REVIEW OF ADDITIONAL EAST LAKE – FYSHWICK STP ODOUR STUDY REPORTS

Lolita No 1 And Lolita No 2 Pty Ltd C/- Molonglo Group

Job No: 6791A

2 November 2012

Figure 2-1: Proposed Buffers within the CEE Report

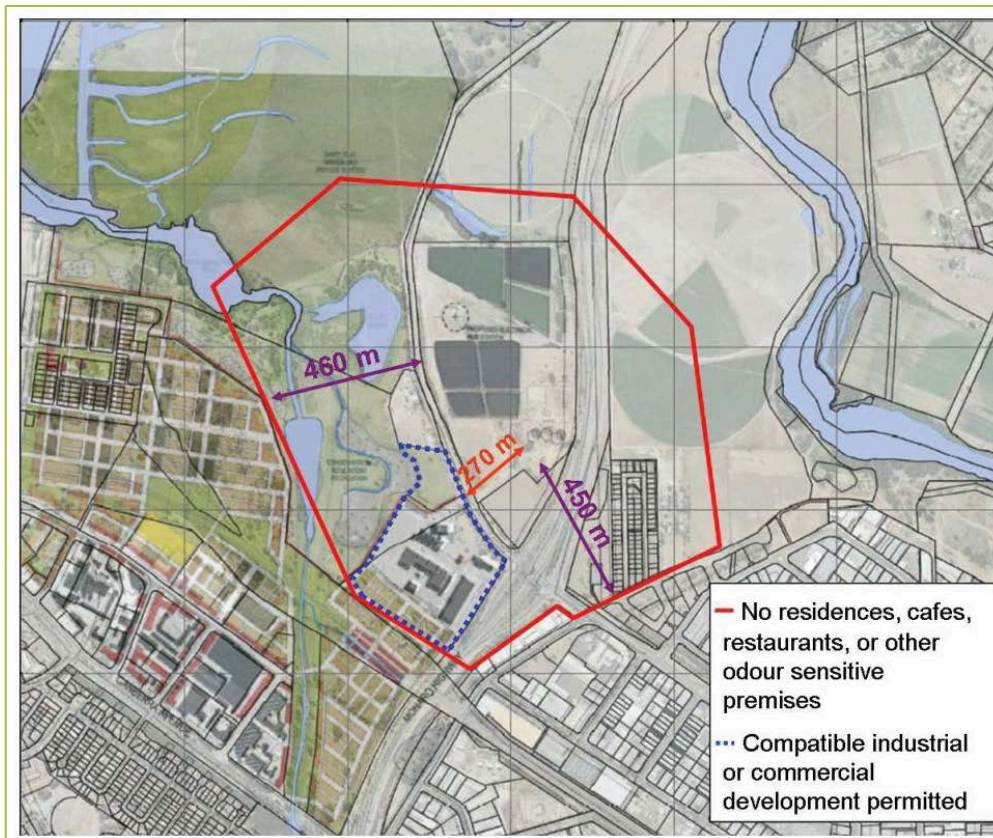
These buffers shown in **Figure 2-1** appear to have been based on the model outputs assuming lagoons used as maturation ponds, and not facultative ponds, as discussed above. It is concluded that insufficient detail is provided to support the creation of such a buffer.
